PLANNING COMMISSION MEETING

4.A. PC Case 20-04 – Site Plan, Preliminary And Final Plat Review To Allow A Climate Controlled Storage Building At 1665 Oakdale Ave. – More Space LLC

To: **Planning Commission**
From: **Melissa Sonnek, City Planner**
Date: **May 19, 2020**

Site Plan, Preliminary, & Final Plat for 1665 Oakdale Ave – More Space LLC

A1 Site Plan
CS01 1" = 20'-0"

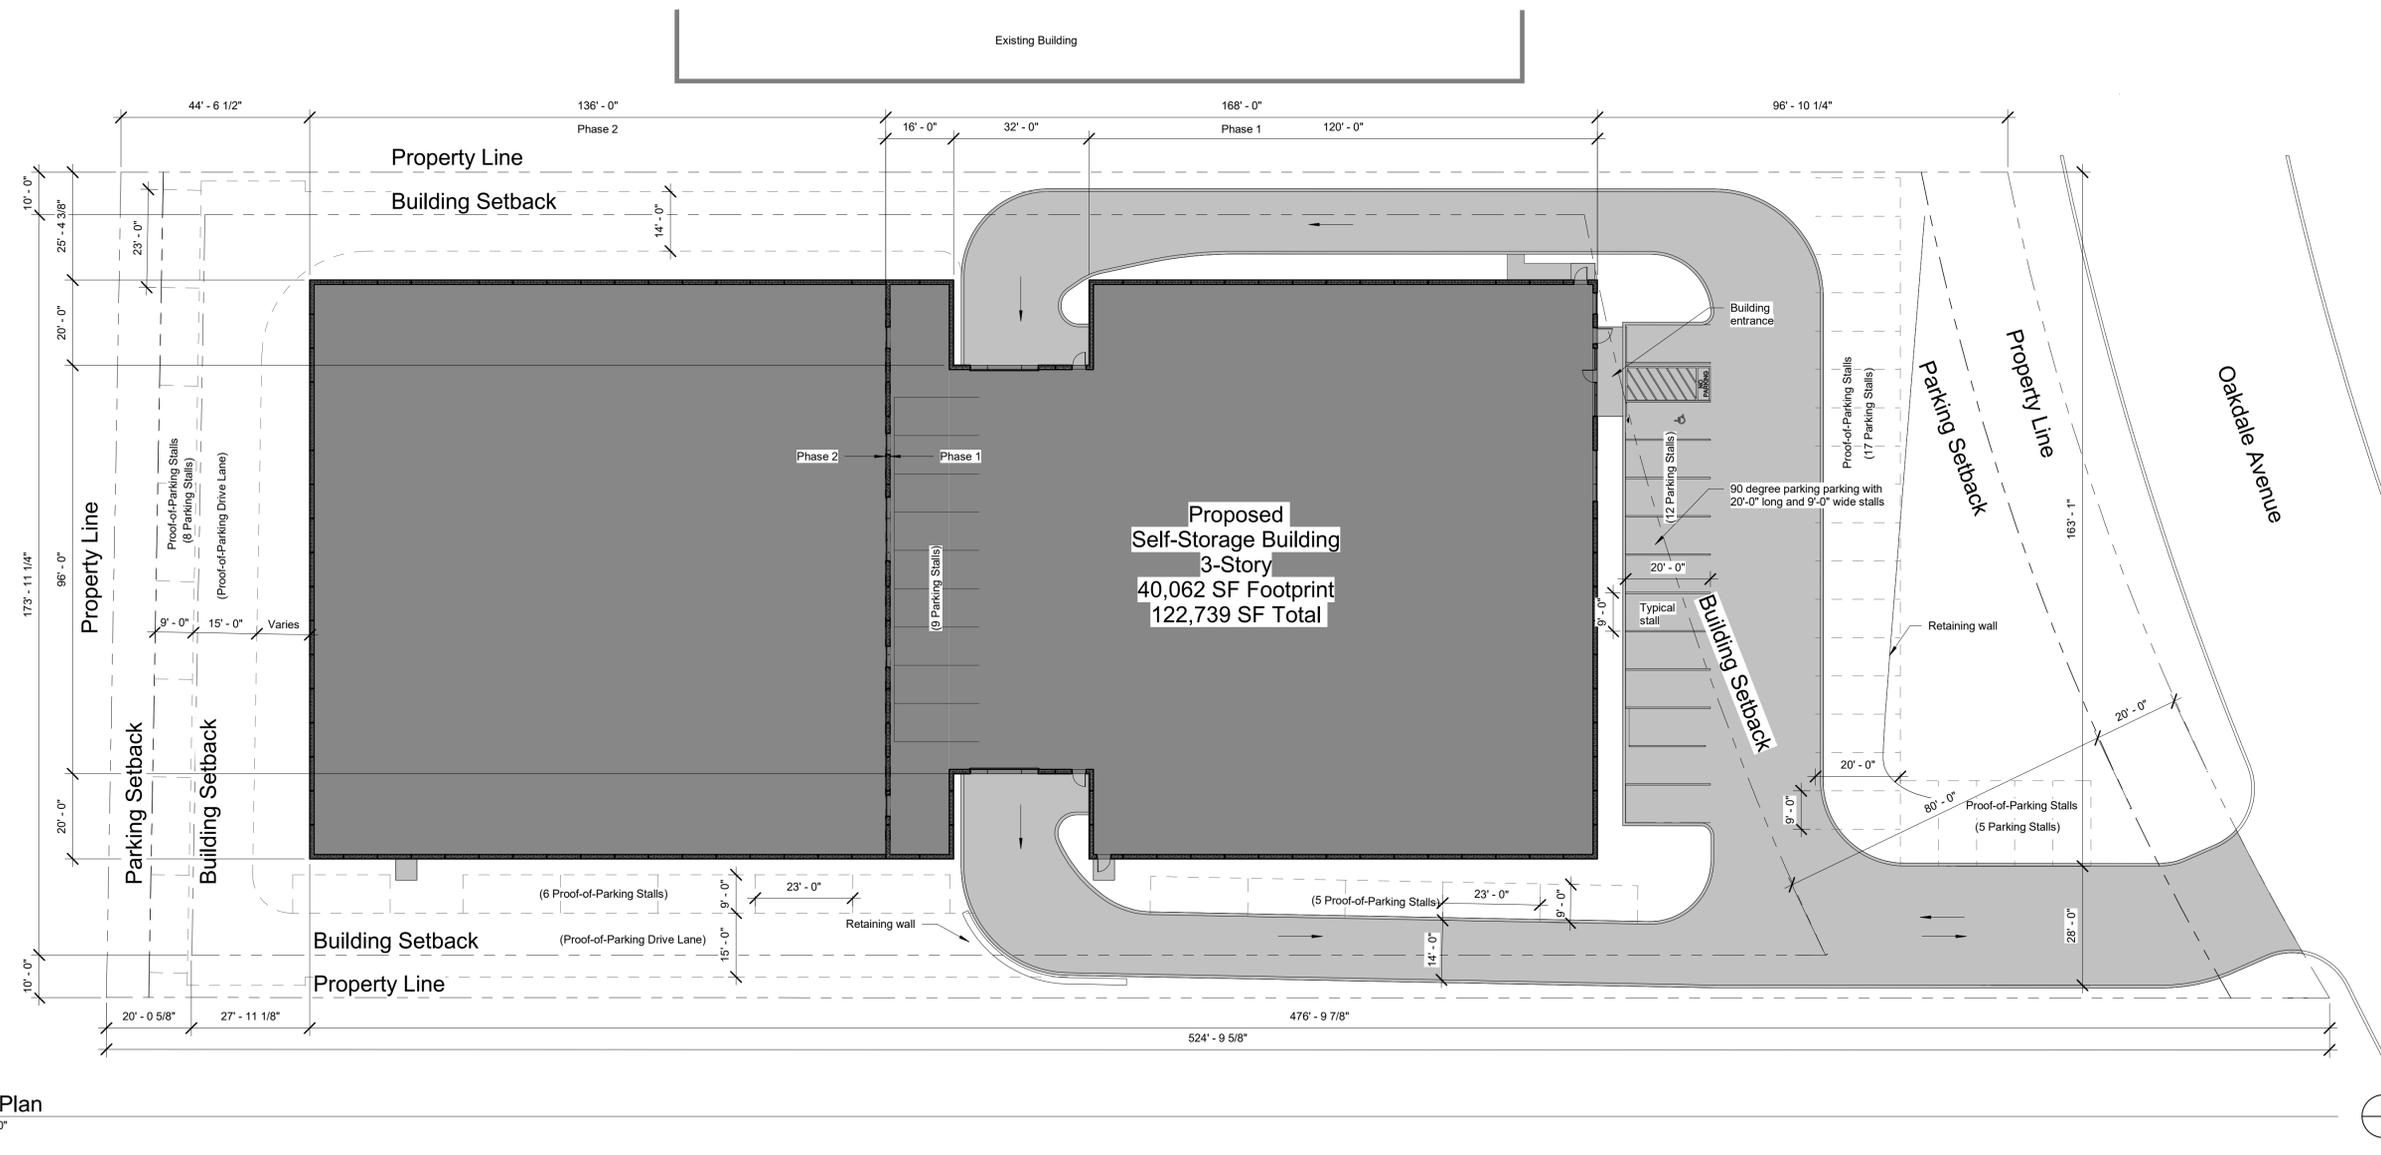
The applicant is proposing a total of 21 parking stalls (as well as 41 proof of parking) for this project, 12 surface stalls located at the front of the building and 9 stalls located within the building that will be used for loading and unloading. The applicant has stated that they see these stalls used the most, while only a few of the surface stalls are used at a time.

Code requires one parking stall per 2,000 sq. ft. of floor area, which for this site equates out to 61 stalls. The code does allow for proof of parking, which the applicant has agreed to provide in the future if/when the stalls are needed. For the time being, City Staff would much prefer to see the area occupied by additional trees and greenspace rather than un-used parking stalls.

The submitted plans show a two-way drive aisle width of 26 ft., parking stall depths of 20 ft., and stall width of 9ft. All are compliant with code minimums which are 22 ft., 20 ft., and 9ft. respectively. The

The submitted lighting plans do show a small amount of lighting at a few sections of the property line. Since code requires the lighting levels be zero foot-candles at the property lines, City Staff is recommending as a condition of approval that the lighting plan be revised so that the lighting levels do not exceed zero foot-candles at all abutting property lines, and no direct glare may extend into the public street, public open space, or neighboring properties.

3. The applicant shall revise the lighting plan to ensure that all lighting levels will not exceed zero foot candles at all abutting property lines, and no direct glare shall extend into the public street, public open space, or neighboring properties,

Landscape Plan

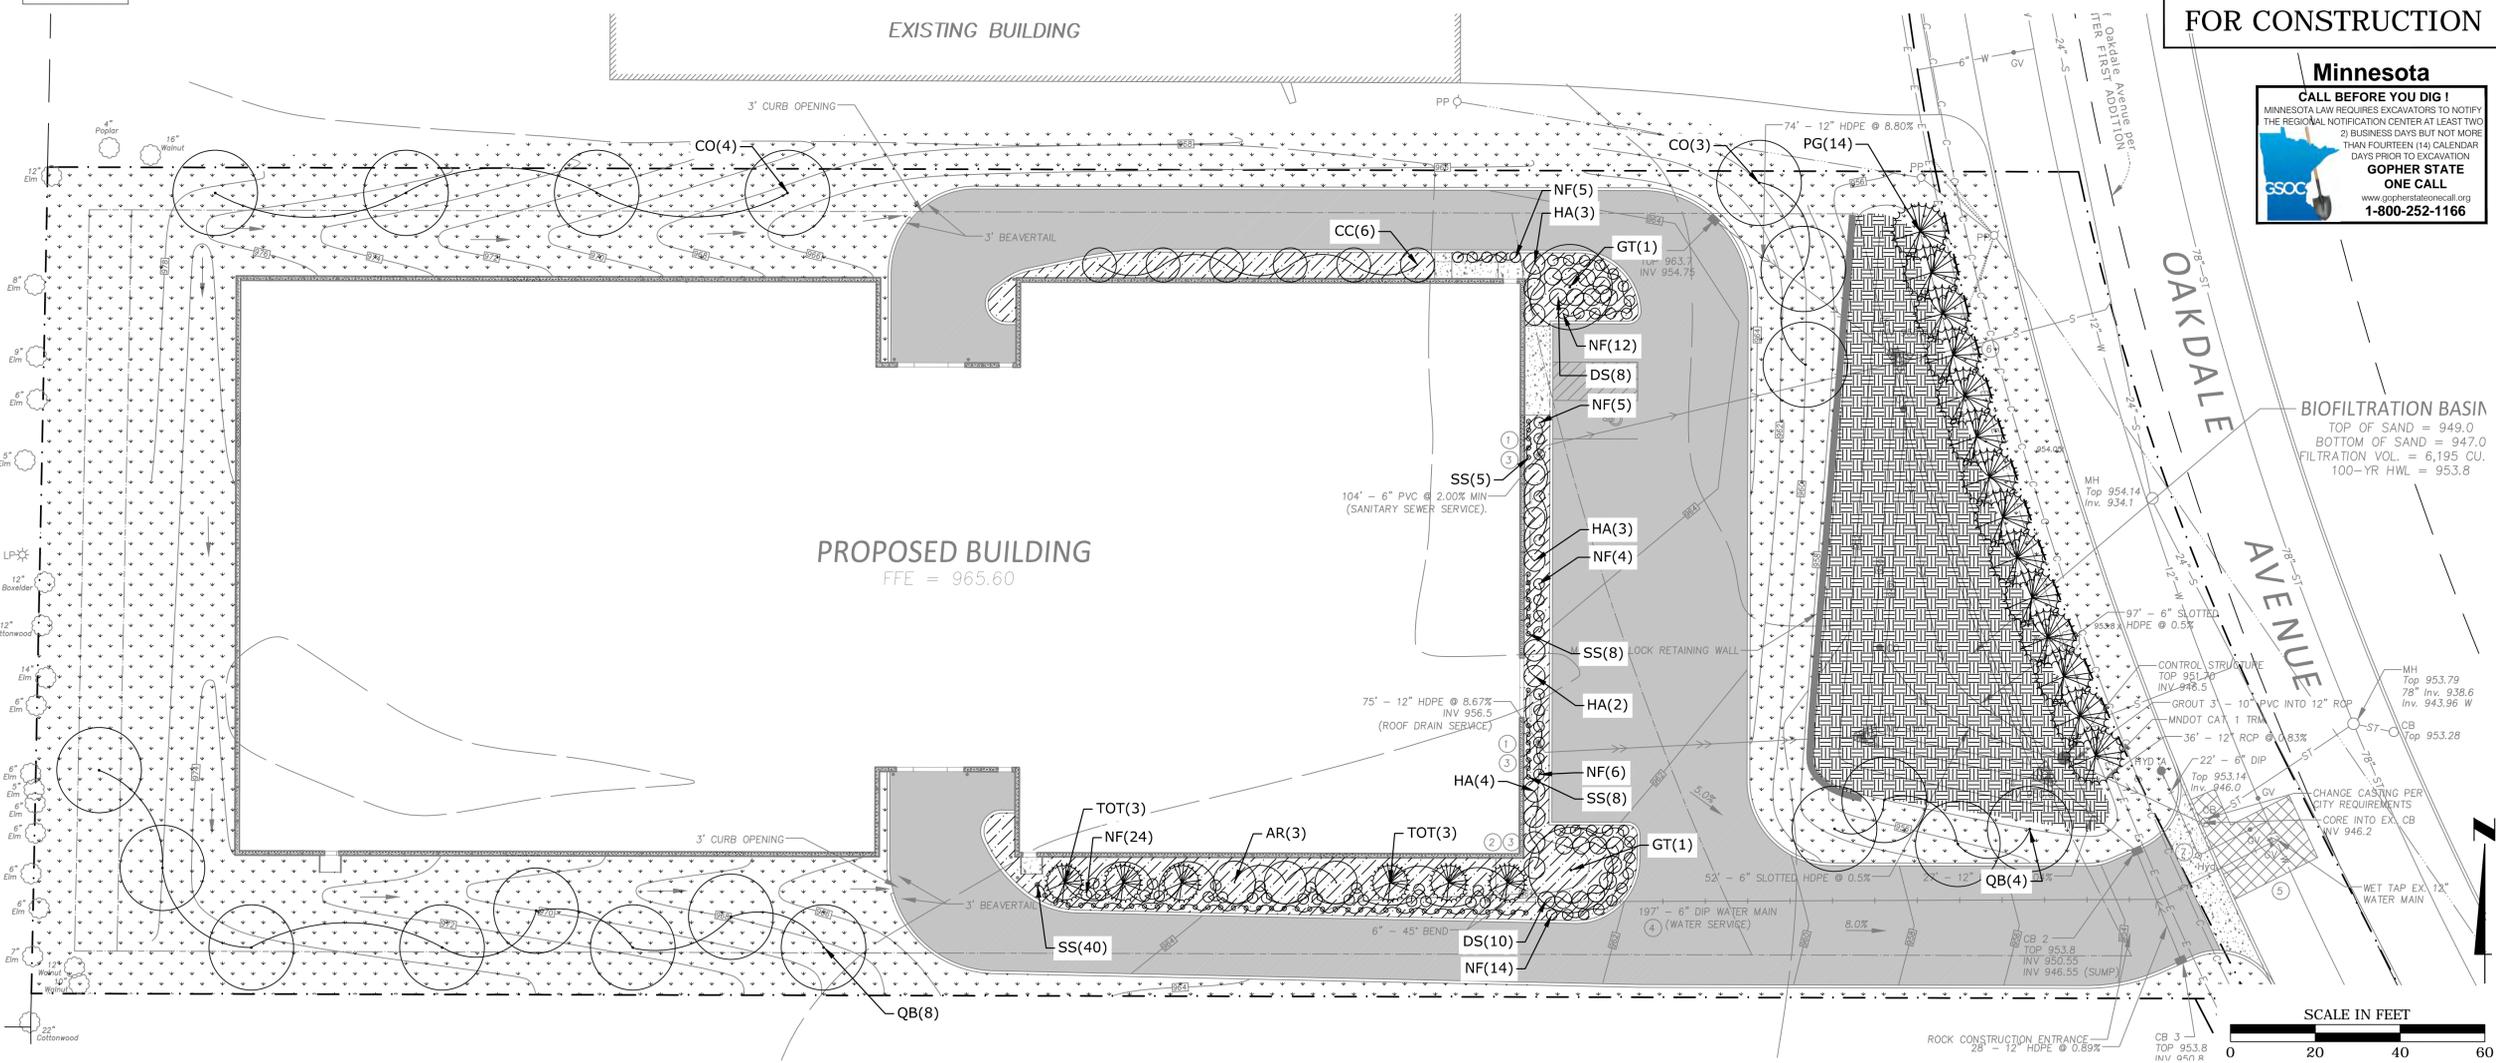
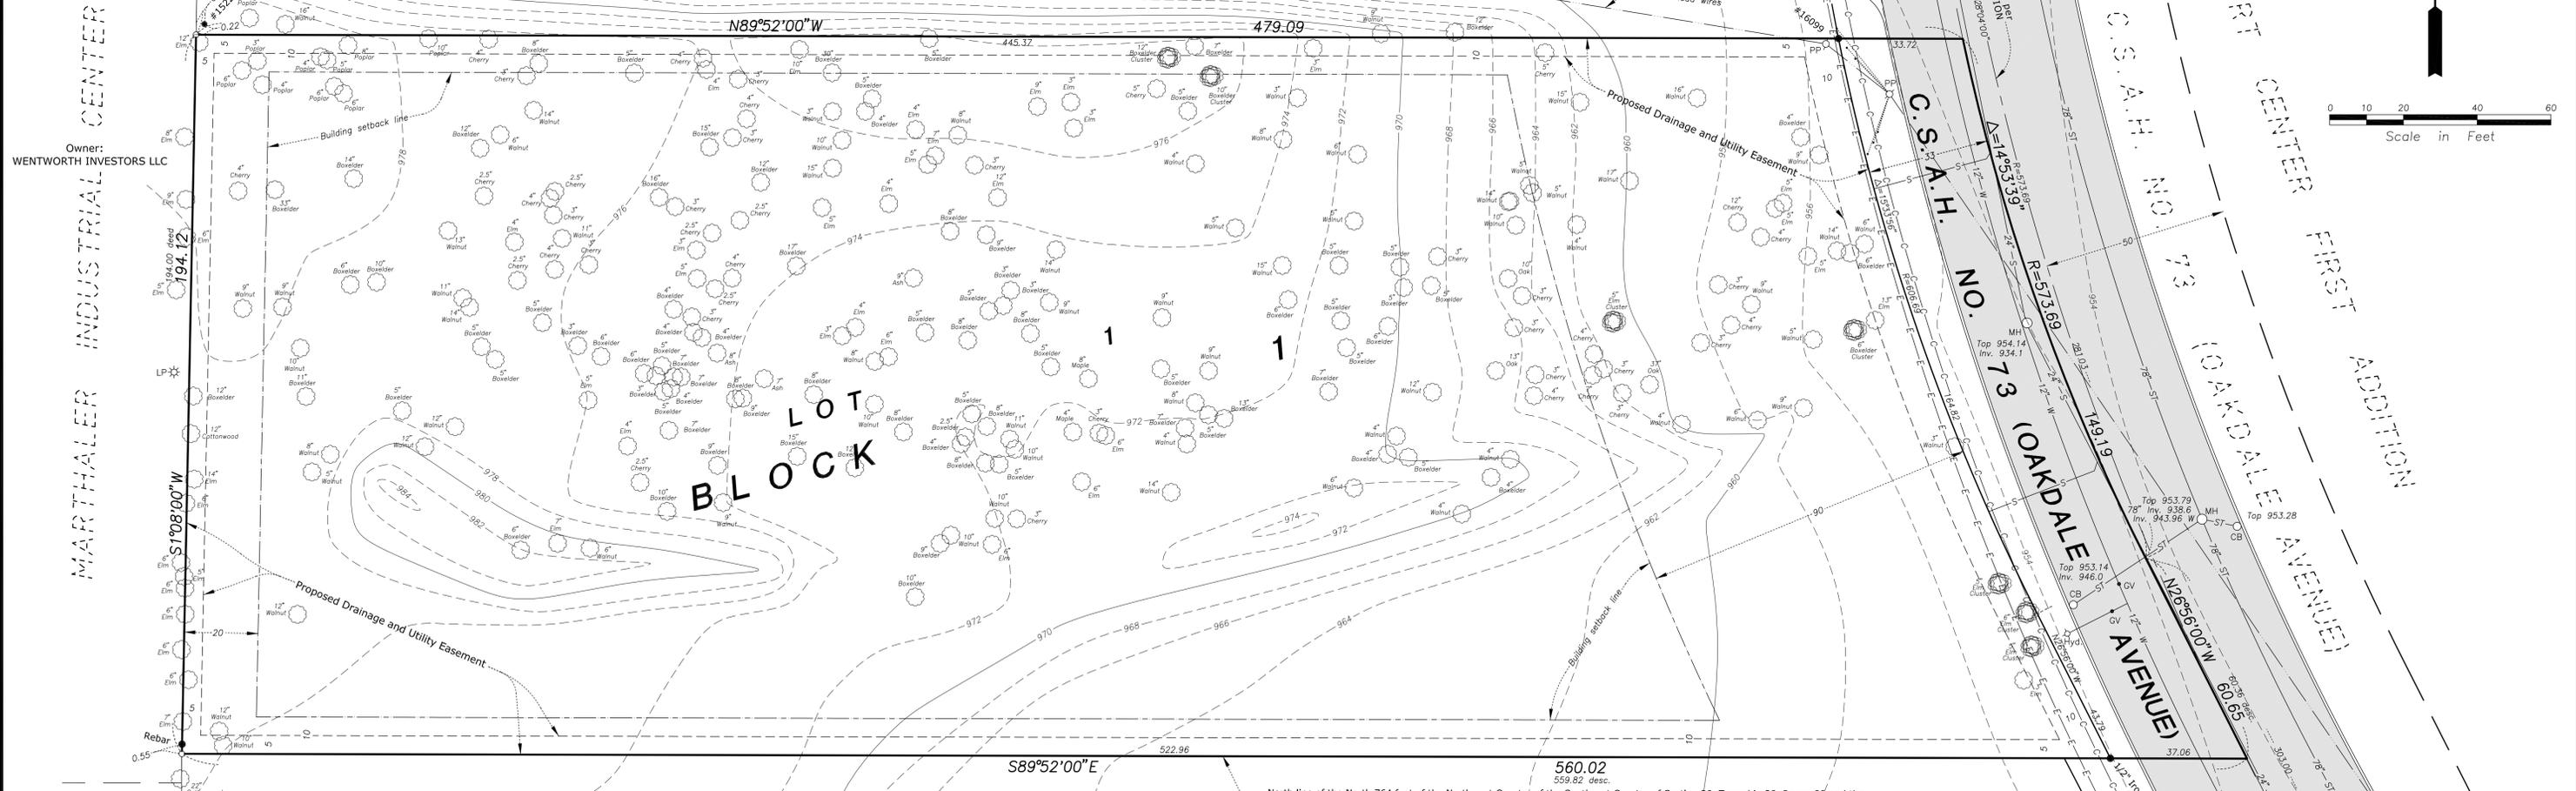
The submitted plans detail the removal of 104 quality trees (740 caliper inches). The zoning ordinance requires that whenever the removal of quality trees occurs, a minimum of 30 percent must be replaced. For the proposed removal, the required caliper inches to be replaced equates out to 222 caliper inches (or 89 trees that measure 2.5 caliper inches). The submitted plan numbers fall just short of the required minimum while proposing a total of 210 caliper inches (see landscape plan for specifics). As a result, City Staff is recommending as a condition of approval that the applicant either increase the number of trees or caliper inches of the proposed trees to meet the 222 caliper inches needed to meet the minimum.

In addition, for development/redevelopment in commercial and industrial districts, the code requires one tree per 20 lineal ft. of property line, which for this property (1,398 lineal ft.) equates out to 70 trees. As shown in the attached plans, the applicant is proposing 50 deciduous trees, totaling to 210 caliper inches, as well as 30 shrubs, 70 perennials, and 61 ornamental grasses. Staff is comfortable with the lower number of trees since the proposed size of the trees is larger. Specifically the 14 evergreens located in the front yard that are expected to measure 30ft. in height.

The Committee approved the proposed variety and number of trees for the site, they also liked the addition of the bio-retention pond. In addition to the proposed landscaping, the committee agreed that dark sky compliant lighting and a green roof would be a great addition to this development.

Overall, Members liked the stormwater plan and the addition of the bio-retention pond, as well as the variety and selection of plantings. Members did not like the great loss of mature trees on the site and the fact that full required replacements are not being met, but understand there is limited space for new trees. Other comments by Members included the addition of Dark Sky compliant lighting, a green or white roof, and additional screening along Oakdale due to the destination park across the street.

4. The applicant revise plans to either increase the number of trees or increase the caliper inches of the proposed trees to meet the 222 caliper inches minimum requirement,

Lighting and Signage

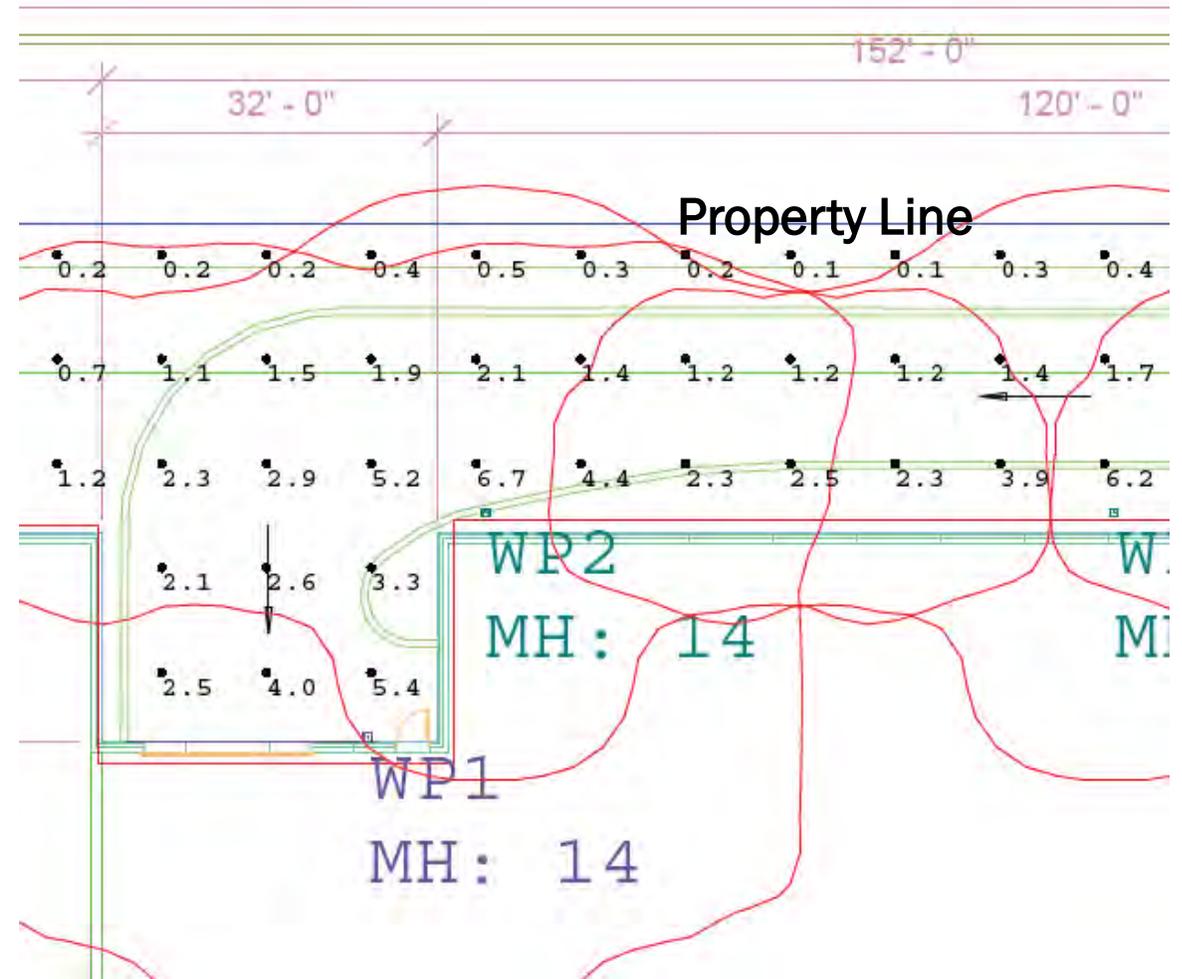
- The submitted lighting plans do show a small amount of light at the property line
 - City Staff is recommending the lighting plan be revised so lighting levels do not exceed zero foot candles at property lines

- The submitted plans do not include detail on signage for the property
 - City Staff is recommending that all signage comply with section 153 of the zoning ordinance

3. The applicant shall revise the lighting plan to ensure that all lighting levels will not exceed zero foot candles at all abutting property lines, and no direct glare shall extend into the public street, public open space, or neighboring properties,

PLANT SCHEDULE

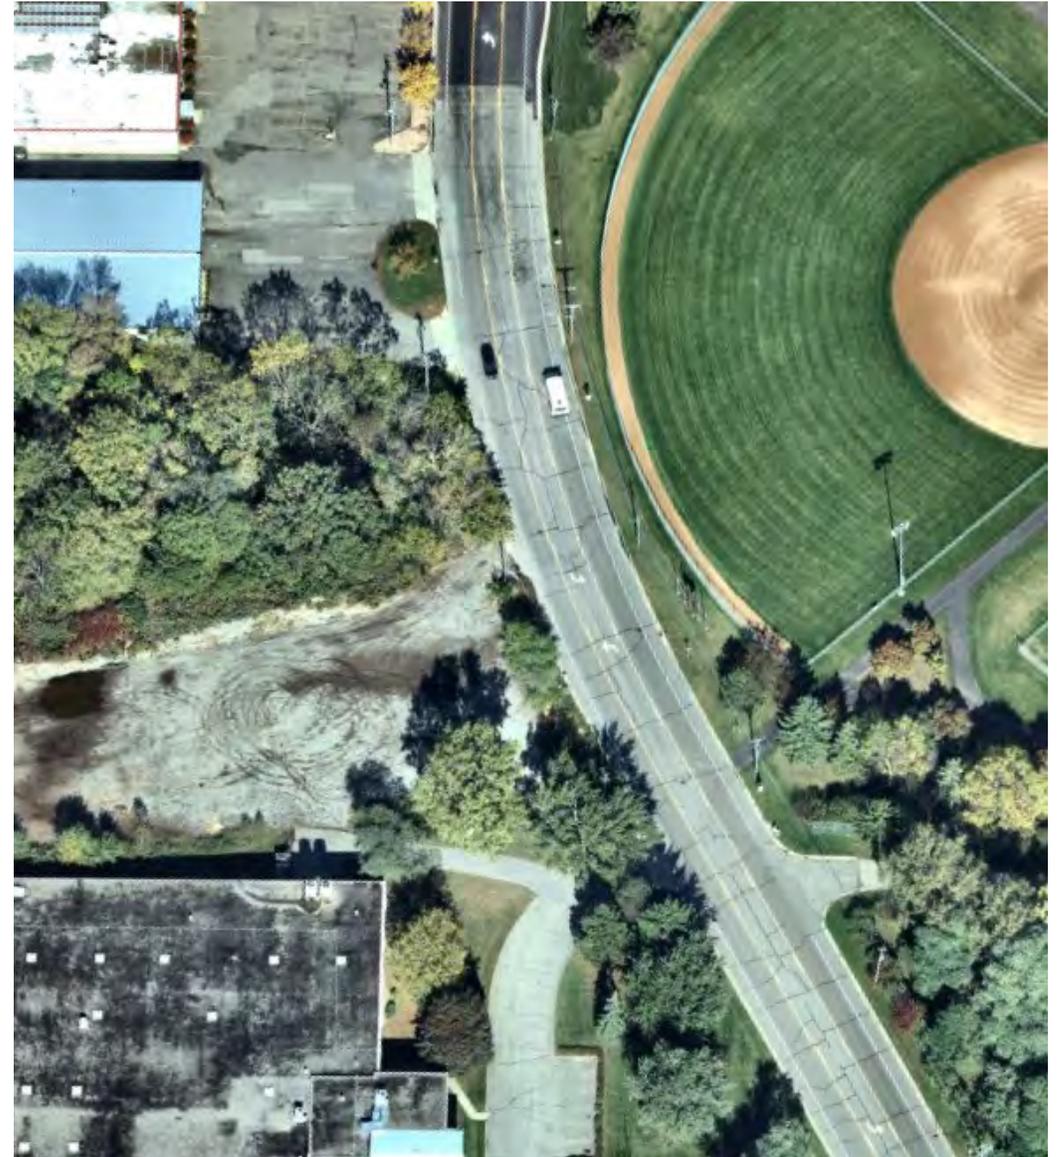
The Environmental Committee performed in informal review of the plans, and the following comments were made:

- Use of pollinator friendly native plants that are not treated with neonicotinoids,
- Creation of a green roof for added stormwater treatment,
- Implement dark sky compliant lighting

- The applicant consider the site plan additions recommended by the environmental committee in the April 13th memo
